My name is Kent Knutson, I reside at 4061 Old Stone Road. Our property lies about 1200 to the Northwest of the Proposed CUP I oppose the CUP application because it has a number of inaccurate statements, false truths, or out right make believe statement. It also fails to meet Standard 1 and Standard 4.

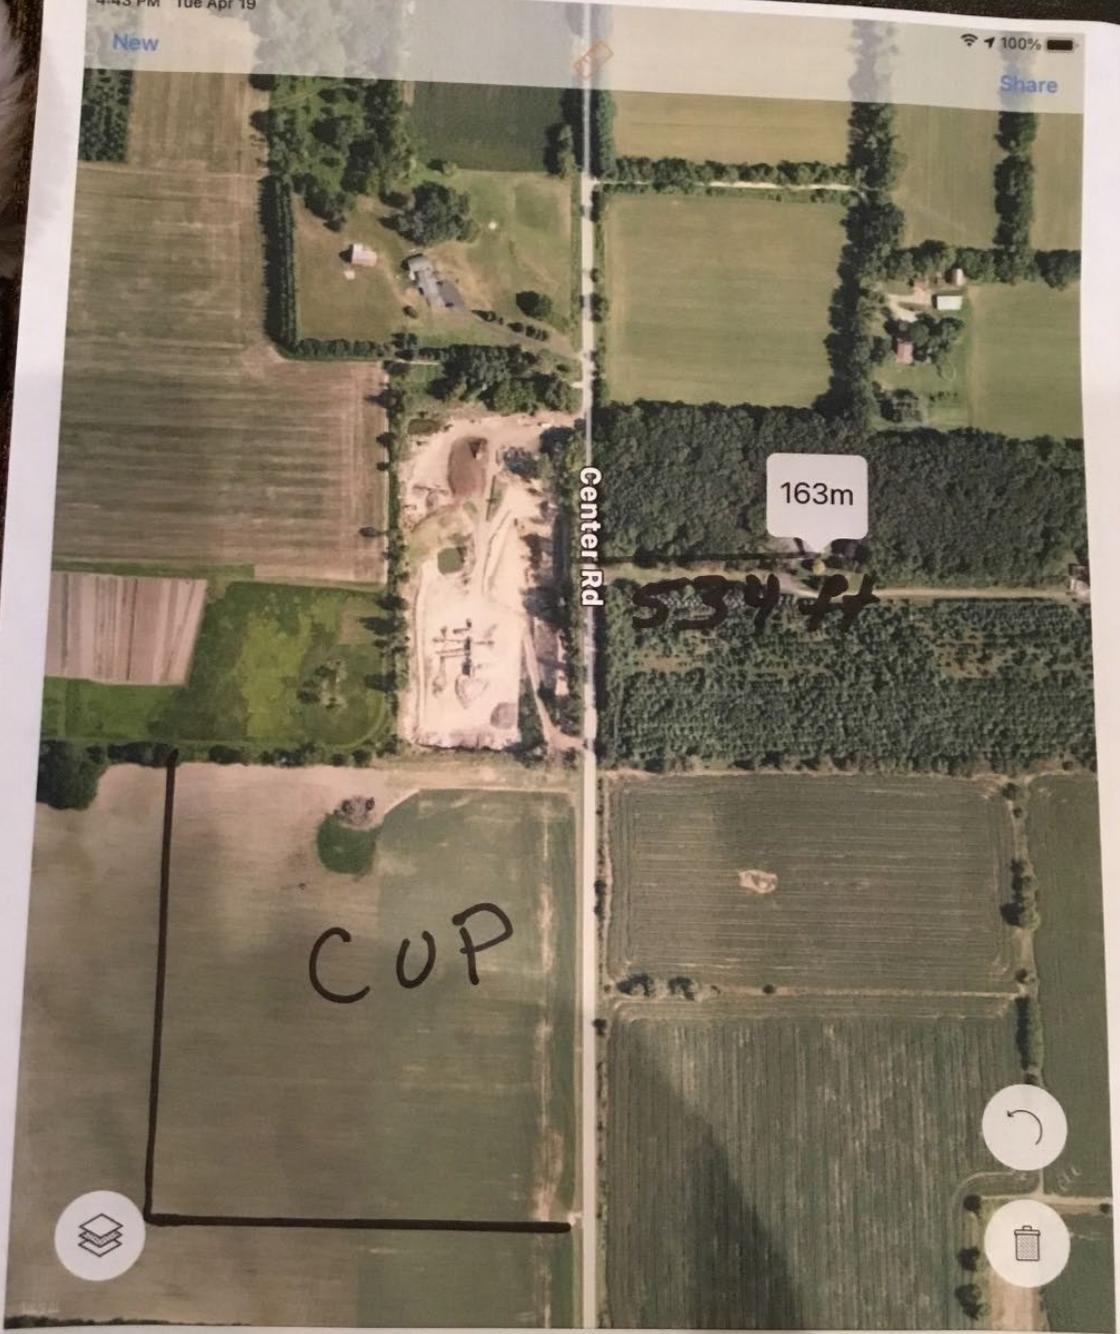
Page 8 (Aesthetics). You state the surrounding landscape shields the quarry view from all sides. This statement is not true. I have full view of all of your running equipment, trucks, excavators, skid loaders, trucks and personal pickups. I watch the crusher, the excavator, and several trucks move about every day. I provided a photo of my view every day. The new CUP is the same view.

I have provided a photo that shows the only (wooded) area around the project are the scrub trees/brush/ noxious weeds on your property line along Center Road. There were about a dozen trees that you have bulldozed down. there is an open view from most all viewpoints except the applicants personal residence.

You will see photos provided that there are 5 homes, some less than one block from the proposed CUP. The length of one city block ranges from 300 feet to 500 feet.
